CONSTRUCTION SUMMARY		RECEIVED	
Charisma Condominiums - Dulcina Investments Inc.		JUL 04 2023	
PURCHASER: Davison THIRUGNANASAMPANTHAR		TEL:	
Unit 3, Level 23 (2403-5)	Floor Plan C970

THE FIFTH
AT CHARISMA

C 970
TOWER SUITE
9' CEILING
970 sq. ft.
2-BEDROOM

Unit 3, Level 23 Suite 2403

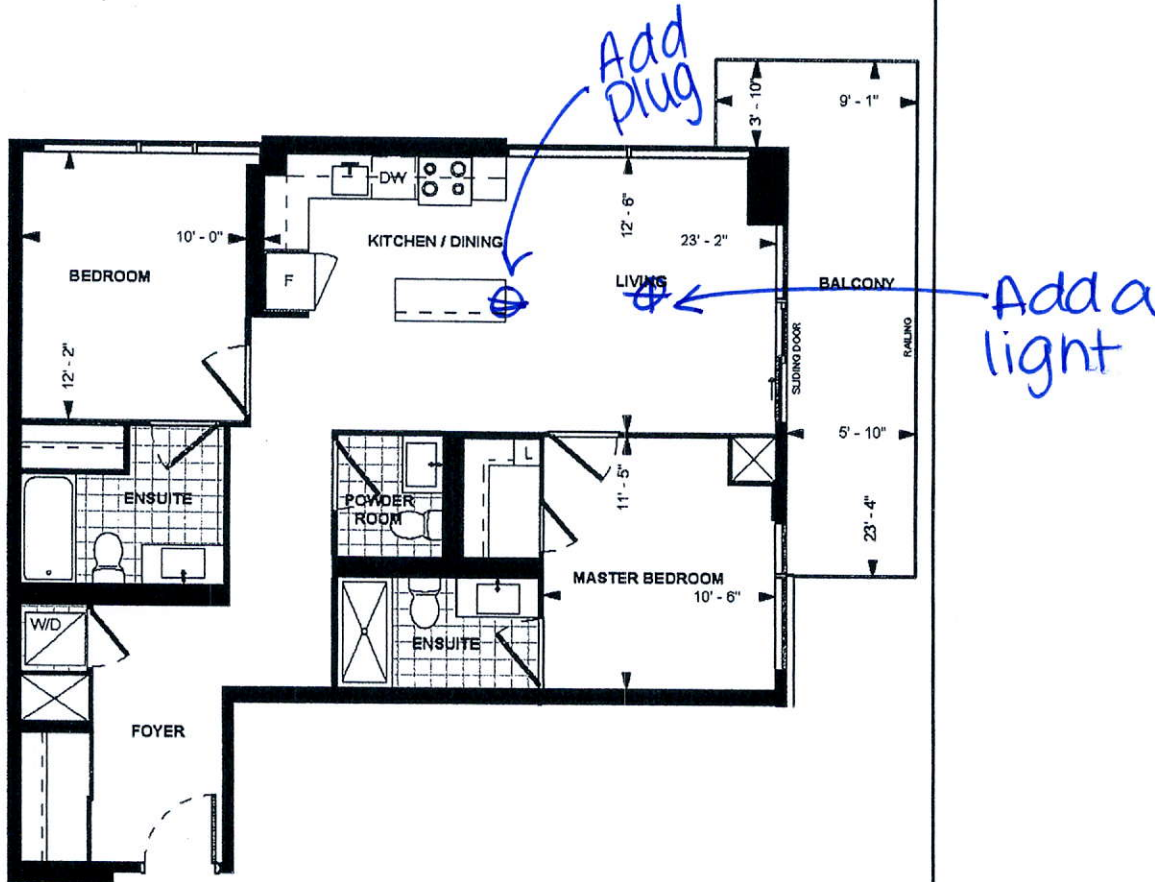
1 - CABINETRY PROVISION - PROVISION FOR PLUG ON ISLAND (PLUG EXTRA ORDERED SEPARATELY) 15Jun23 Note:	
---	--

1 - PLUG - ADD PLUG AT ISLAND 15Jun23 Note:	
1 - LIGHT - ADD CEILING LIGHT COMPLETE WITH FIXTURE AND SWITCH 15Jun23 Note:
